SAN ANTONIO WATER SYSTEM
Interdepartment Correspondence Sheet

Subject: Zoning Case Z2022-10700334 (Bulverde Project)

Date: August 23, 2023

Figure 3

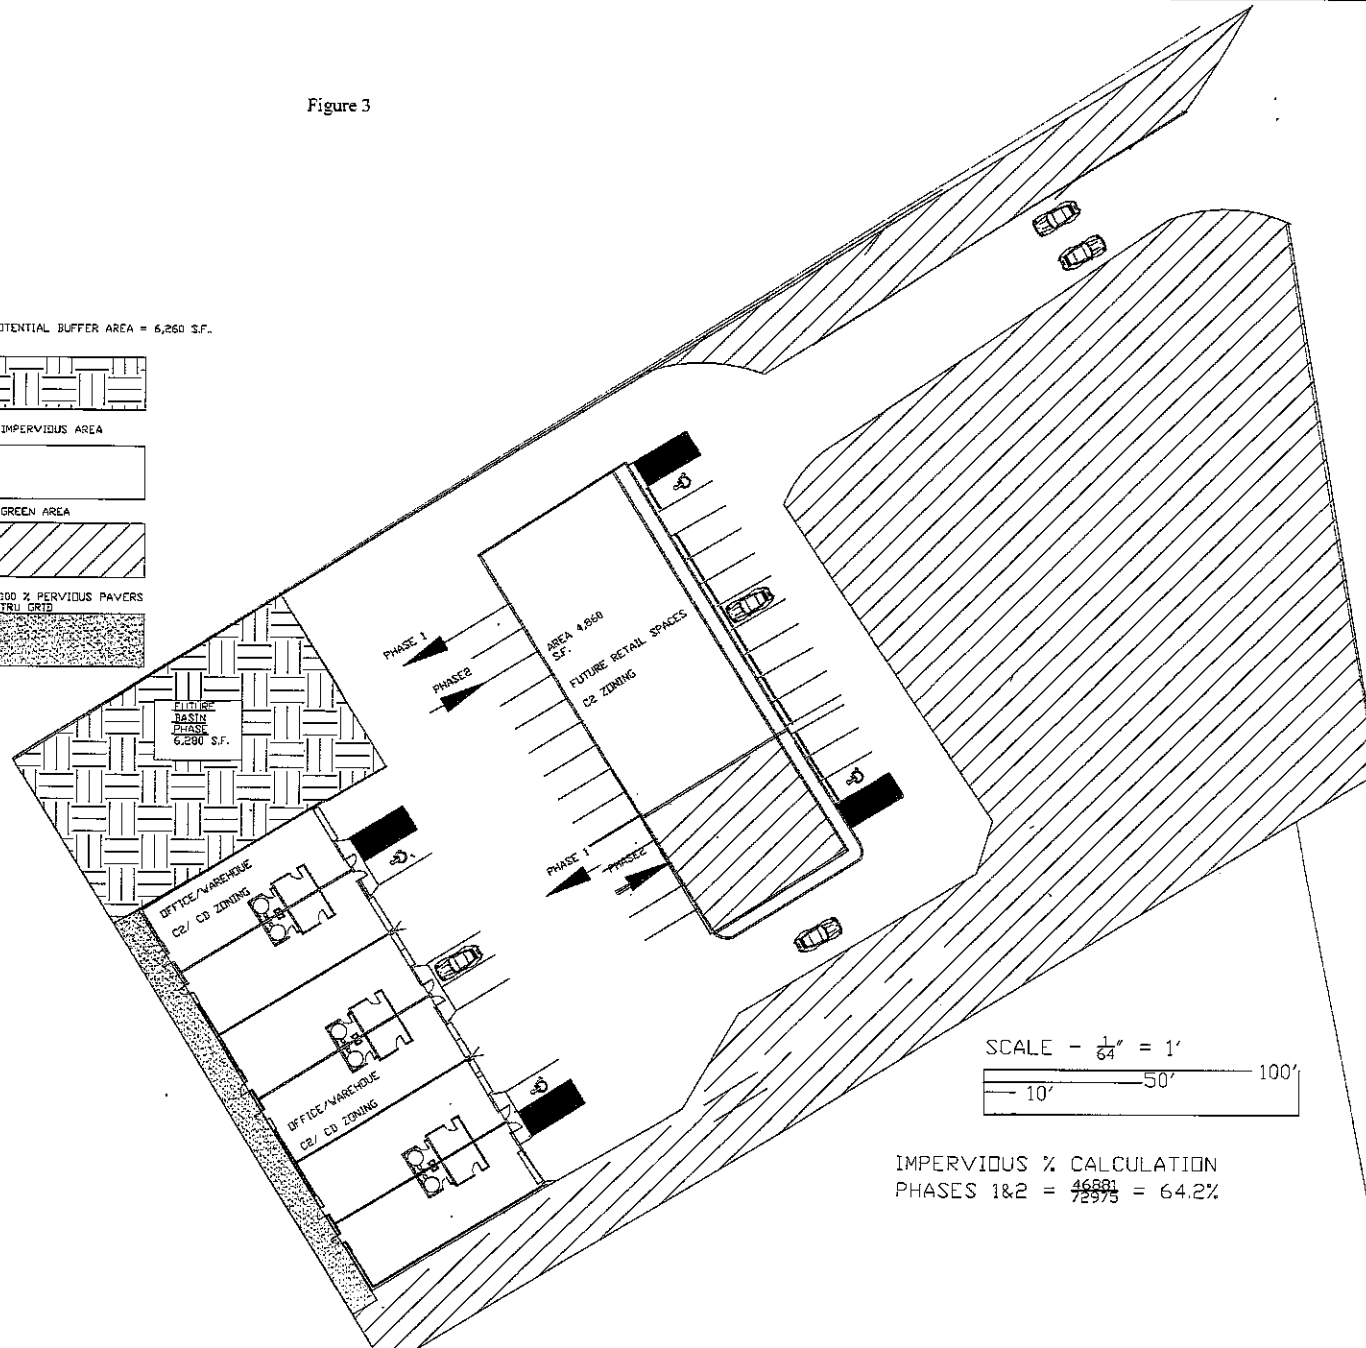
1. The impervious cover shall not exceed 64.20% on the 1.675-acre site.
2. A natural buffer shall be provided for the preserved Black Cat Cave located on-site as required in Ordinance No. 81491, Section 34-920. The location of the natural buffer is further shown in the submitted conceptual site plan, attached as Figure 3 and Figure 4. The intent of this exhibit is to show the location and buffering of the sensitive geologic feature, however, the remainder of the site is subject to change. No building permit will be issued until final plans are approved with the appropriate buffer preserved.
